UNITED STATES PATENT AND TRADEMARK OFFICE

APPLICATION NO.	FILING DATE	FIRST NAMED INVENTOR	ATTORNEY DOCKET NO.	CONFIRMATION NO.
10/584,161	03/29/2007	Juergen Eberle	2003P01969WOUS	5081

Office Action Summary	Application No. 10/584,161	Applicant(s) EBERLE ET AL.	
	Examiner JONATHAN KOAGEL	Art Unit 3744

DETAILED ACTION

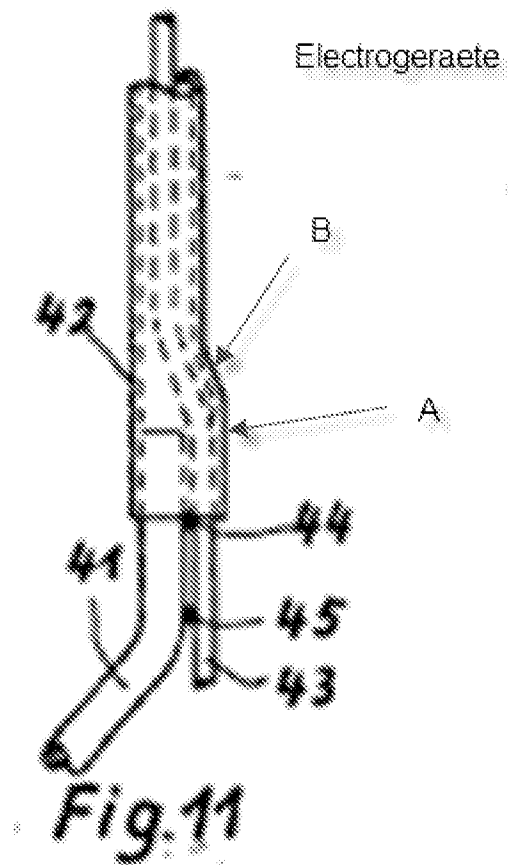
Regarding claim 7, Electrogeraete teaches in fig. 11, a refrigerating unit comprising a suction tube 41, 42 and a throttling tube 43 which runs at least over a part of its length inside the suction tube 41, 42 and is guided out from the suction tube 41, 42

to form a first outlet location 44 wherein the throttling tube 43 and the suction tube 41, 42 are joined to one another at a second location 45 of the suction tube 41, 42 at which outer surfaces of the throttling tube 43 and the suction tube 41, 42 are in contact, wherein the outer surfaces of the throttling tube 43 and the suction tube 41, 42 are joined to one another at the second location 45 by welding (pg. 4 paragraph 7).

Regarding claim 8, Electrogeraete teaches in fig. 11 that the first and second locations, 44 and 45 are spaced apart at a distance. Electrogeraete fails to explicitly teach where the second location is spaced apart from the first location at a range of 5mm to 20mm.

Regarding claim 9, Electrogeraete further teaches in fig. 11 wherein the second location 45 is located downstream from the outlet location 44 with reference to the refrigerant flowing in the suction tube 41, 42.

Regarding claim 10, Electrogeraete further teaches in fig. 11, wherein the outlet location 44 is provided at a connecting tube A (labeled by examiner) on which both the suction tube 41, 42 and the throttling tube 43 are fixed downstream in a liquid and gastight manner (pg. 4 paragraph 7). Electrogeraete discloses that the tubes are brazed and welded at the locations 44 and 42. Therefore, the tubes are fixed in a liquid and gastight manner.

Regarding claim 11, Electrogeraete further teaches in fig. 11, wherein the suction tube 41, 42 has an expansion B (labeled by examiner) for the throttling tube 43 in the area of the outlet location 44.

Regarding claim 12, Electrogeraete further teaches in fig. 11, a method for joining a suction tube of a refrigerating unit to a throttling tube comprising the following acts, guiding the throttling tube 43 out from the inside of the suction at an outlet location 44 of the suction tube 41, 42, joining the suction tube 41, 42 and the throttling tube 43 at the outlet location, bringing in contact an outer surface of a portion of the throttling tube 43 located outside the suction tube 41, 42 with an outer surface of the suction tube 41, 42 at a second location 45 of the suction tube 41, 42, joining the suction tube 41, 42 and the throttling tube 43 at the second location 45, joining the outer surfaces of the suction tube 41, 42 and the throttling tube 43 to one another at the second location 45 by welding (pg. 4 paragraph 7). Regarding the joining of the suction tube and the throttling tube at the outlet location by soldering, Electrogeraete teaches an equivalent technique of brazing which allows both the tubes to become joined together by the use of a filler metal which melts and creates a sealed joint. Both brazing and soldering use a filler metal that melts and creates a sealed joint without the melting of the surfaces that are being joined. Electrogeraete fails to explicitly teach the use of ultra sound welding.
